JOINT REGIONAL PLANNING PANEL (Hunter and Central Coast)

Supplementary Council Assessment Report

Panel Reference	2016HCC022
DA Number	49564/2016
Local Government Area	Central Coast Council
Proposed Development	Residential Flat Building - (101 Units) & Demolition of Existing Structures
Street Address	Lot 1-3 DP 17420, Lots 14, 15, 23, 24 DP 17440, Nos 177-181 Albany Street, 8-10 Duke Street and 2-4 Auburn Street, Point Frederick
Applicant	Point Frederick Real Pty Ltd
Owner	Point Frederick Real Pty Ltd
Date of DA Lodgement	31/03/2016 Amended plans lodged 15/07/2016, 02/09/2016, 19/07/2017 and 10/08/2017.
Number of Submissions	104 to the original application. 58 to the amended plans considered by JRPP on 25 May 2017. (Amended plans the result of the JRPP deferral not required to be exhibited).
Recommendation	Approval - subject to conditions
Regional Development Criteria (Schedule 4A of the Act)	Development with a capital investment value over \$20m
List of all relevant s79C(1)(a) matters	<ol style="list-style-type: none"> 1. Environmental Planning & Assessment Act 1979 - Section 79C 2. Local Government Act 1993 - Section 89 3. Roads Act 1993 4. Gosford Local Environmental Plan 2014

Figure 4- Development Potential Diagram 6 Auburn St.

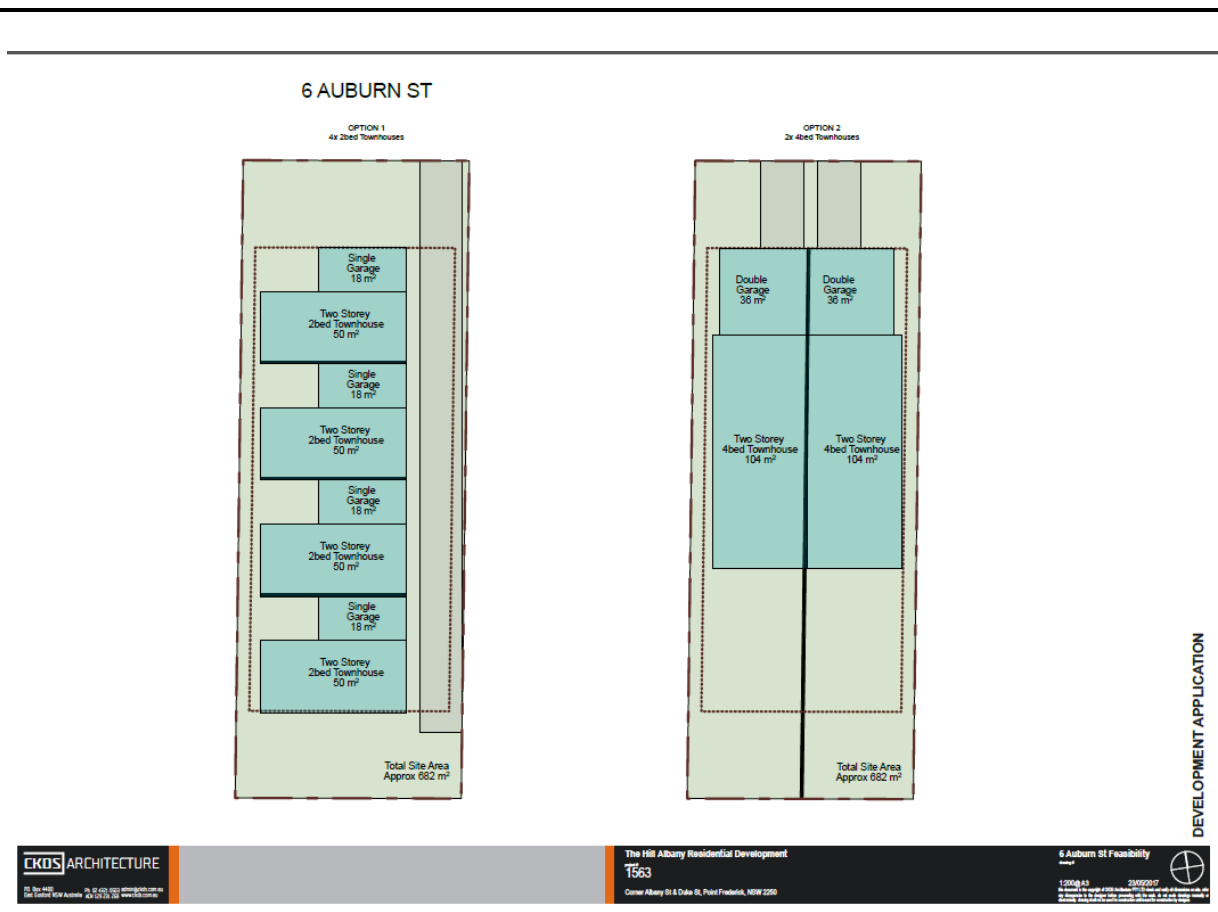
The second principle requires demonstration that if amalgamation is not feasible, the orderly and economic use and development of 6 Auburn Street can be achieved.

If 6 Auburn Street is developed separately, the maximum height limit is 12m and the maximum FSR is 0.75:1 under clause 8.3(2) of the GLEP 2014. The applicant has submitted schematic sketches (see figure 4) that show this would permit two x 4 bedroom townhouses, or four x 2 bedroom multi dwelling housing units, as shown in figure 4. Similar developments have been approved by Council on similar lots in this location albeit with some variations to the planning controls.

It is concluded that both sites can achieve a development that is consistent with the planning controls for each site, or a development of appropriate urban form and with an acceptable level of amenity can be achieved.

The retention of the existing dwelling on 6 Auburn Street or redevelopment in line with figure 4 both are consistent with this transitional stepping of density and mix of built forms.

Figure 6 - DA -104 Rev F. Amended ground floor plan

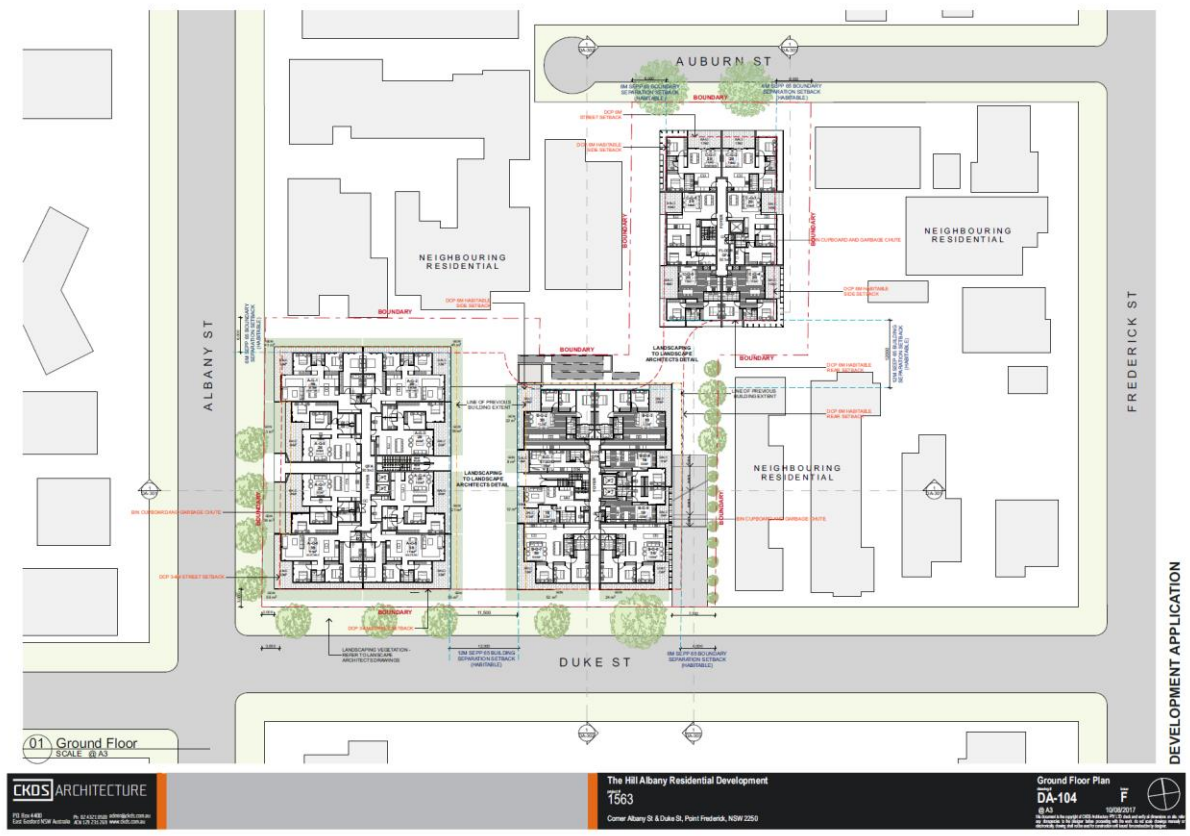
To provide greater built form relief to No. 12 Duke Street, the development has been redesigned in the following manner:

- Building A (western building) has moved 1.0m further west resulting in a reduced street setback to 2m. This now results in a 1m non-compliance against DCP 2013 –Part 4.1 (4.1.2.2.a) which is considered acceptable given it only occurs for the open balconies of Units A-G-1 and A-G-6.*

- Building B (south-eastern building) has moved 1.5m further west, increasing the setback between the driveway and No. 12 Duke Street to 1.5m and between Levels 1-3 to 7.5m (exceeding the DCP side setback requirement). This provides an opportunity to include landscaping along the eastern boundary to further soften the built form. As a result of moving the buildings in the above manner, the following has also occurred:*

Refer to figures 5 and 6.

The movement of the driveway 1.5m away from the boundary with 12 Duke Street, and provision of landscaping and fencing is supported and considered to satisfactorily mitigate the traffic and amenity impacts caused by the driveway to the adjoining site.

Figure 8 - Amended landscape plan buildings A and B.

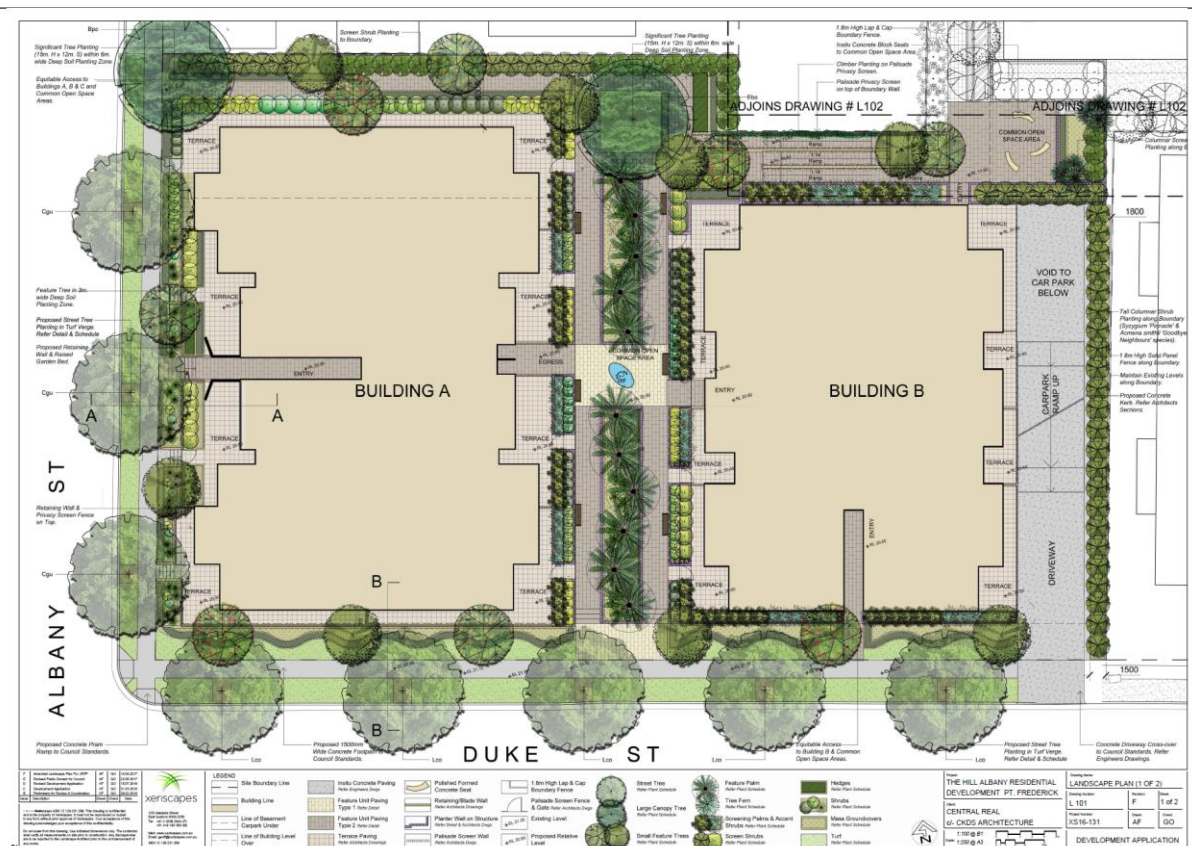
The proposed 7.5m eastern side setback exceeds the minimum required setback of 6m. This permits the provision of landscaping and fencing to mitigate the vehicular noise to the adjoining 12 Duke Street (see figure 8).

The setback area is proposed to be landscaped with a mix of shrubs and groundcovers (see figures 8 and 9). An amended landscape plan has been provided demonstrating that the area between the driveway and the fence is to be densely planted, providing visual softening and shielding.

The landscape plan proposes a 1.8m high solid fence on the eastern boundary. A condition is also proposed which requires a 750mm solid fence/wall on the eastern side of the proposed driveways to mitigate traffic noise. This will provide for improved visual and acoustic amenity.

Figure 11 - Variation to 15.6m height plane

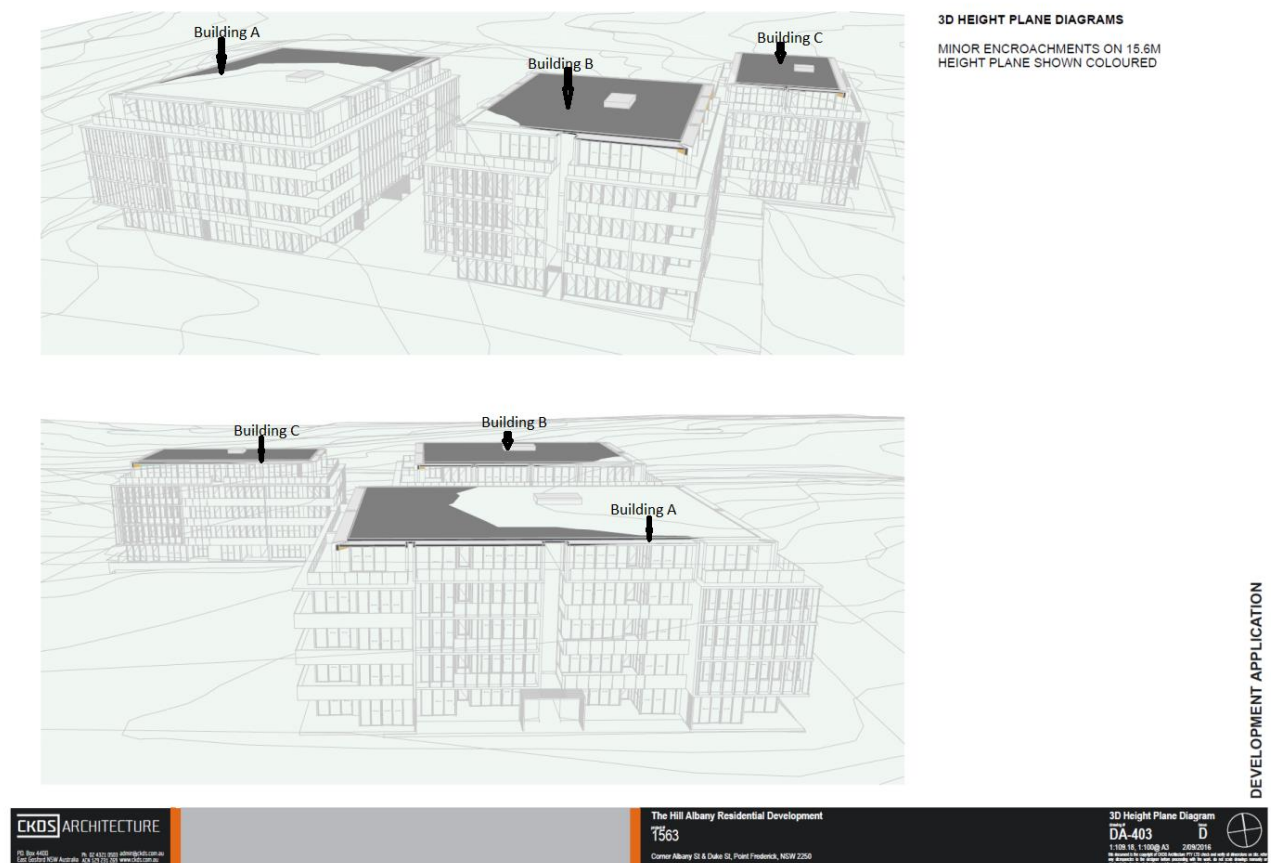
The maximum height is 15.6m (including the 30% bonus permitted under Clause 8.9 of the GLEP 2014). Part of the proposal exceeds the 15.6m height limit, the encroachments over the height limit are shown coloured grey in Figure 11.

Building A has a height of up to 16m. This is a variation of 0.4m or 2.5%.

Buildings B and C have a height up to 16.8m. This is a variation of 1.2m or 7.7%.

The applicant's written request has adequately justified that compliance with the development standard is unreasonable and unnecessary in this instance and there are sufficient environmental planning grounds to justify the variation of the development standard.
